SUMMARY OF CONCERNS IN RELATION TO THE PROPOSED NORTHCONNEX TUNNEL

This is an objection to many aspects of the proposed NorthConnex tunnel.

SECTION A: THE CONNECTIVITY OF NORTHCONNEX SOUTHERN VENTILATION FACILITY AT THE SOUTHERN INTERCHANGE, THE SOUTHBOUND TUNNEL IN PARTICULAR

Figure 5-17 Motorway operations complex

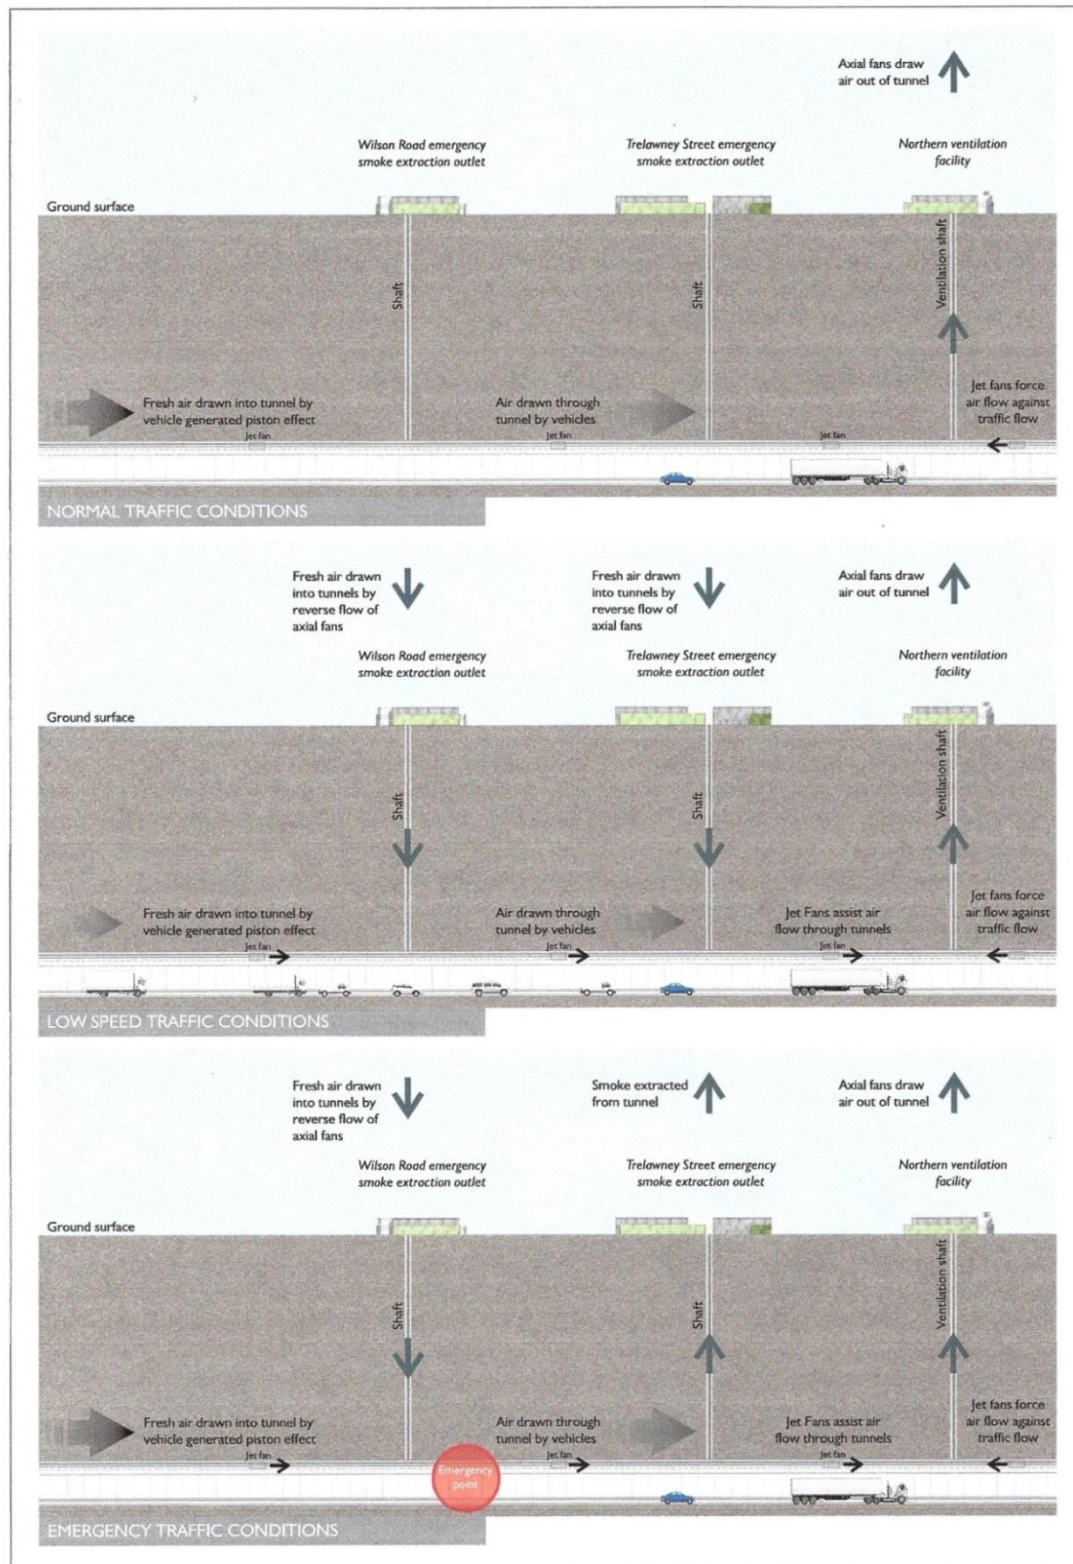
EIS Page 111, *Figure 5-17 Motorway operations complex*

Page 8 below there is no indication of how the ventilation facility will be connected to either the northbound or southbound tunnel, nor is there any indication of how the southbound exit portal onto Pennant Hills Road or the south-west exit portal onto the M2 will be connected.

The following information, which is missing from the EIS, needs to be provided:

- Will the Southern Ventilation facility be connected to the southbound tunnel? In the complete absence of any indication in the EIS that this will occur, it is necessary that this question receive a direct confirmation or denial in writing.
- Where will the connection be?
- How will the polluted air from the tunnel reach the ventilation facility which is across a busy 6-lane highway?
- A diagram such as that in the EIS Page 103, *Figure 5-14 Indicative tunnel ventilation system northbound tunnel arrangement* must be provided showing how this will work for the southern interchange. Clearly the polluted air cannot be drawn upward if the ventilation facility is across the road.

- Diagrams need to be provided showing the inter-relation between the shaft, the ventilation outlet and the motorway operations centre with a clear description of what is to be constructed and how it will operate.
- The community needs irrefutable evidence that the polluted air from the southbound tunnel exit portals will not be allowed to flow like an invisible sewer through West Pennant Hills, North Rocks, Carlingford and Beecroft.

Figure 5-38 Indicative southern interchange construction compound

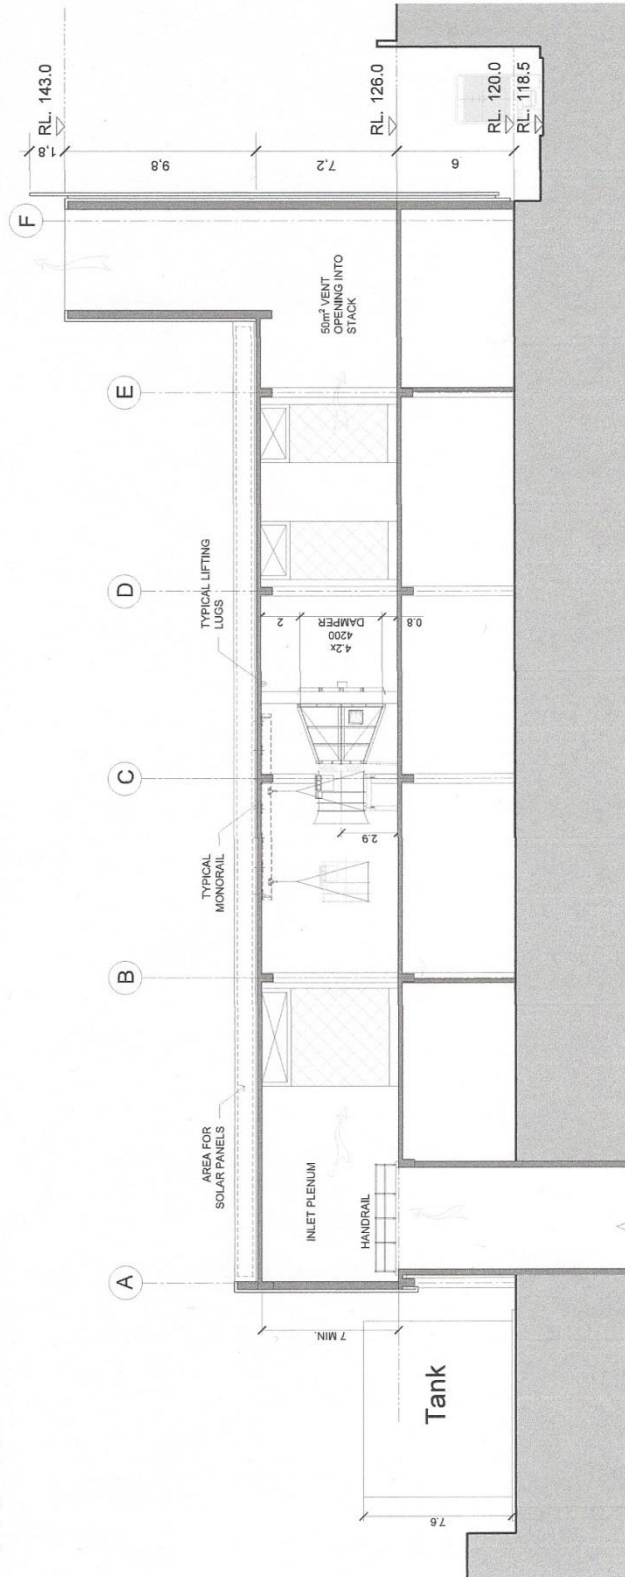
3. EIS Page 189 *Figure 5-38 Indicative southern interchange construction compound* *Page 9 below*

It is ominous that the southern ventilation facility and shaft are completely absent from Figure 5-38.

MOTORWAY OPERATIONS COMPLEX - SOUTHERN VENTILATION FACILITY - SECTIONS
M1-M2-5000-DR-JD-0525

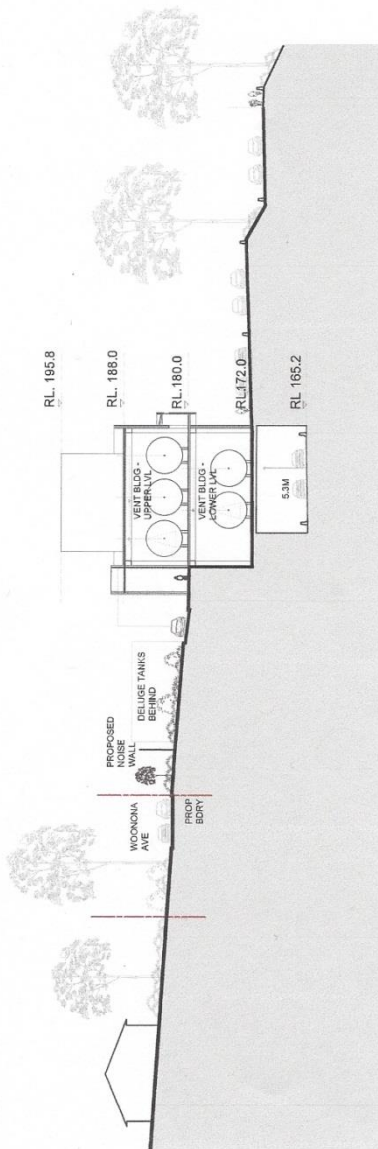
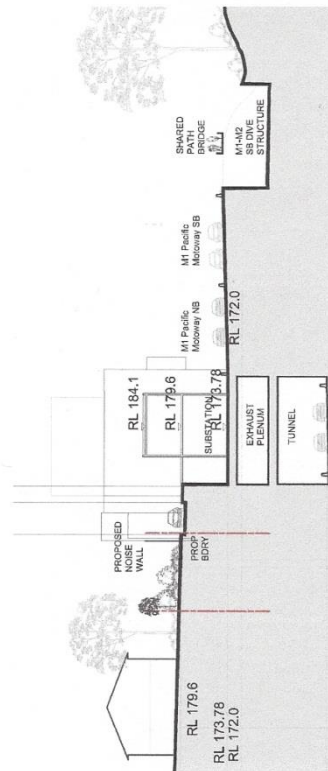
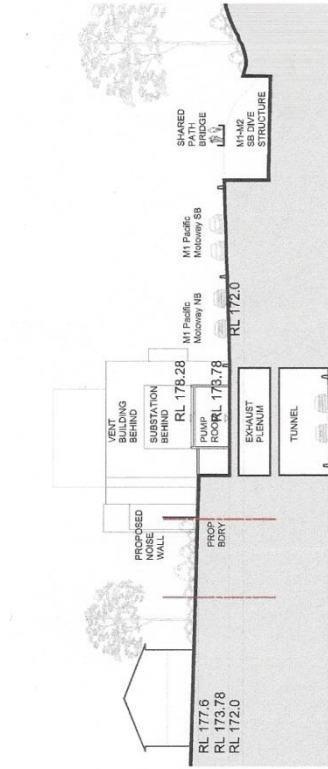
5. *EIS Volume 4, Technical working papers - Urban Design, 6.0 Operational Ancillary Facilities*
EIS Page 99 there is the diagram "Motorway Operations Complex – Southern Ventilation Facility – sections. *Page 10 below* The diagram has the cryptic label "Connection to tunnel TBC". What does TBC stand for? To be considered? Why is tunnel singular? Which tunnel is the diagram referring to northbound or southbound? There is no diagram showing any connection from the Southern Interchange ventilation facility to either the northbound or the southbound tunnel in any way AND YET

Why are there no comparable diagrams for the Southern Interchange and the Southern Ventilation facility?
